MONITORING YEAR 3 ANNUAL REPORT

LONE HICKORY MITIGATION SITE

RE: Lone Hickory Mitigation Site – Monitoring Year 3 Report Draft
Yadkin River Basin – CU# 03040101 – Yadkin County
DMS Project ID No. 97135
Contract # 6897

Wildlands Engineering, Inc. (Wildlands) has reviewed the Division of Mitigation Services' (DMS) comments from the Draft Monitoring Year (MY) 3 report for the Lone Hickory Mitigation Site. DMS' comments are noted below in **bold**. Wildlands' responses to those comments are noted in *italics*.

Figure 3.3 Current Condition Plan View Map (Sheet 3)
 Lone Hickory Mitigation Site
 DMS Project No. 97135
 Monitoring Year 3 - 2021

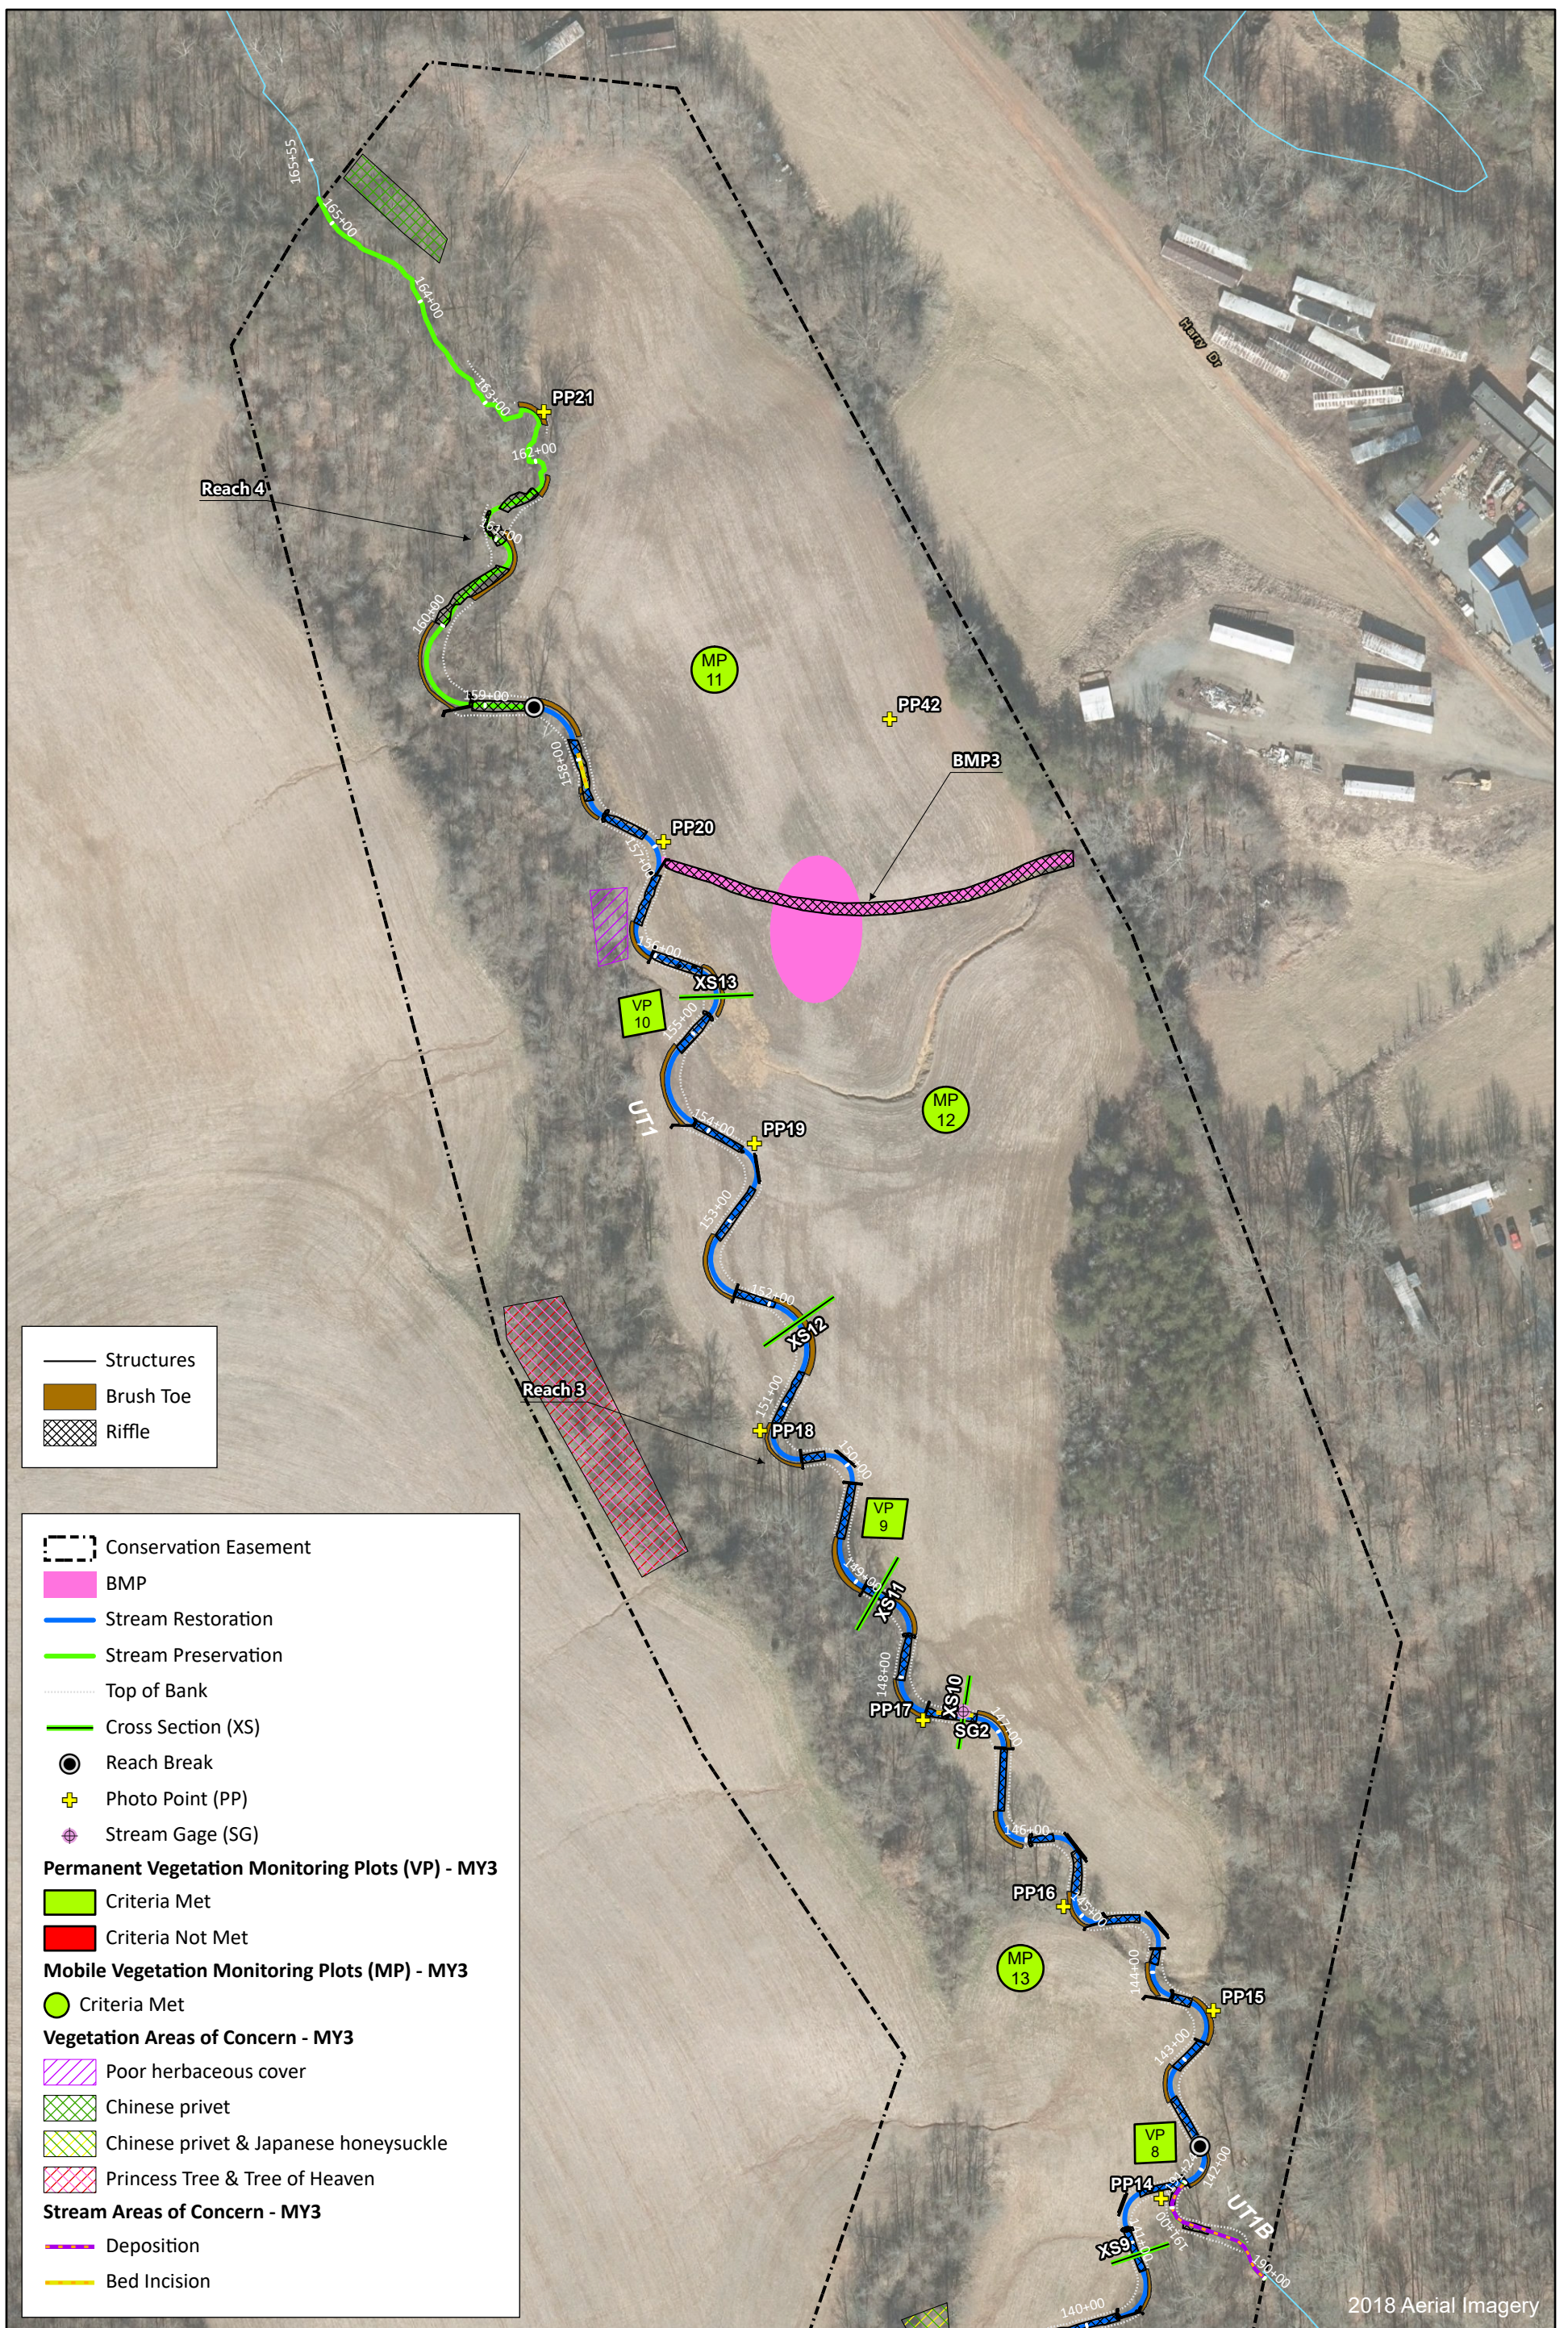
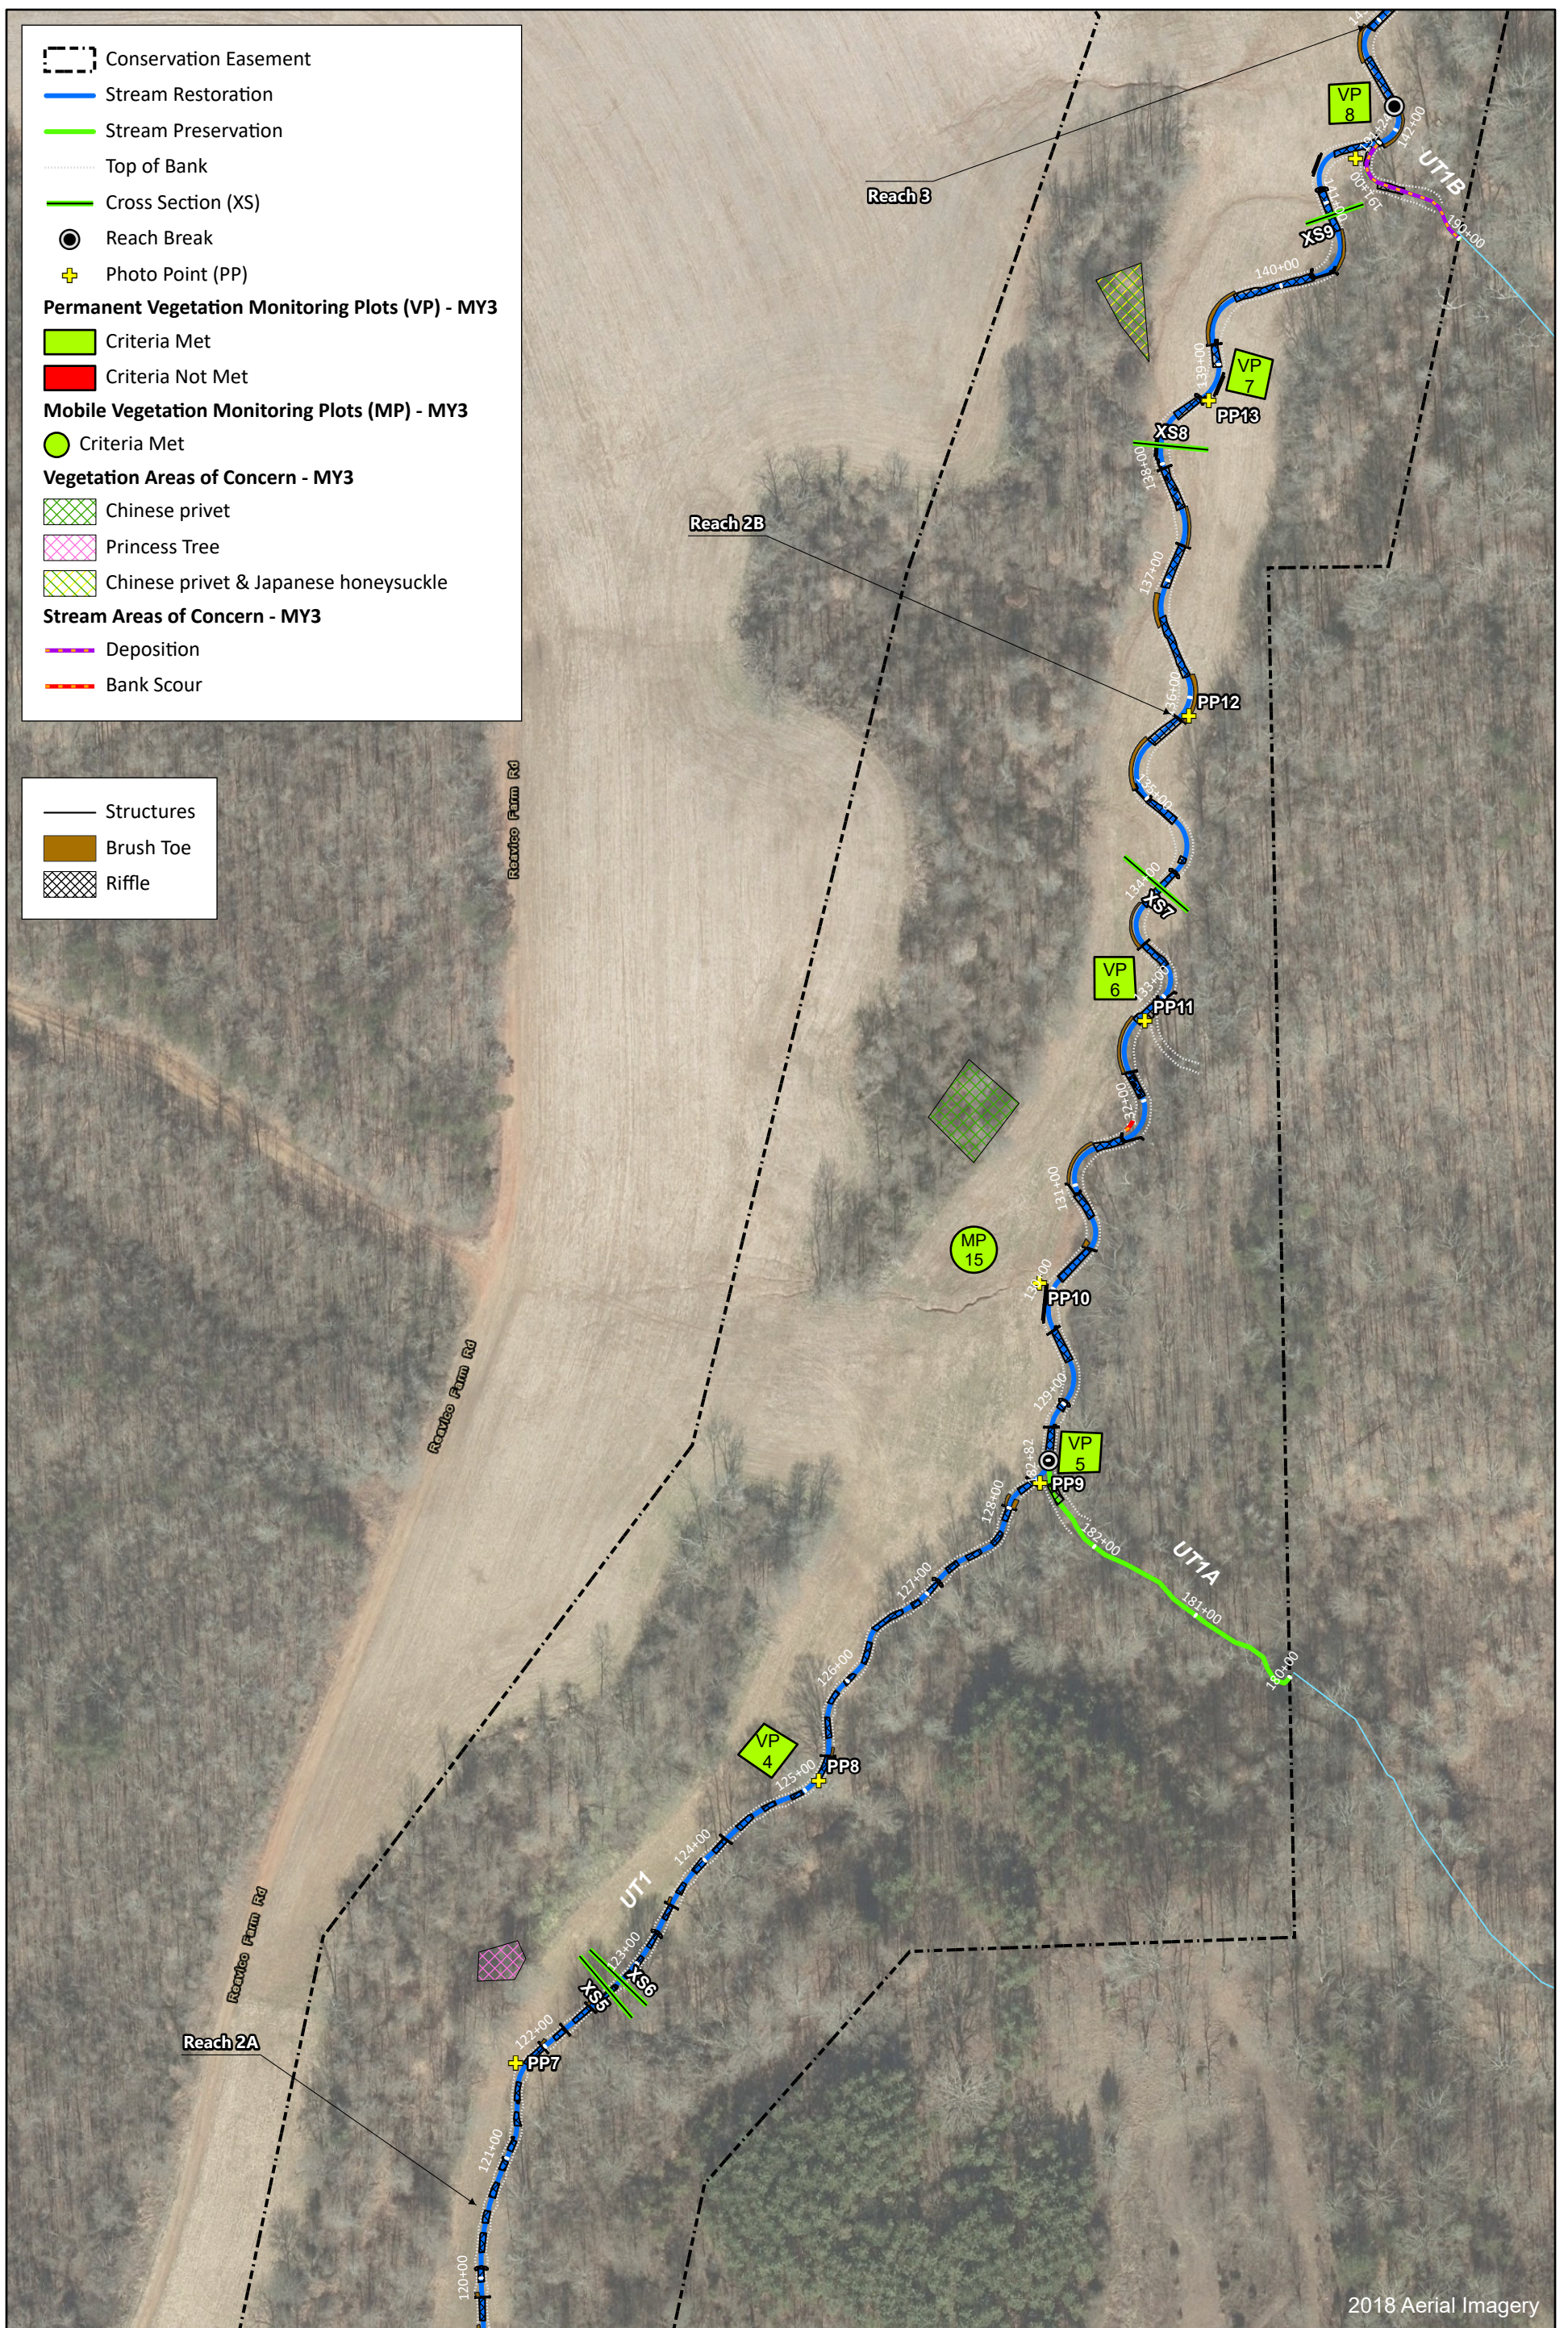
DMS' comment: Section 1.2 Monitoring Year 3 Data Assessment/ 1.2.5 Areas of Concern and Management Activities: The CCPV maps and Table 6 report two (2) structure issues on UT1 Reach 1. Please briefly discuss these structure issues in the report text.

Wildlands' response: Text discussing the structure issues on UT1 Reach 1 has been added to Section 1.2.5.
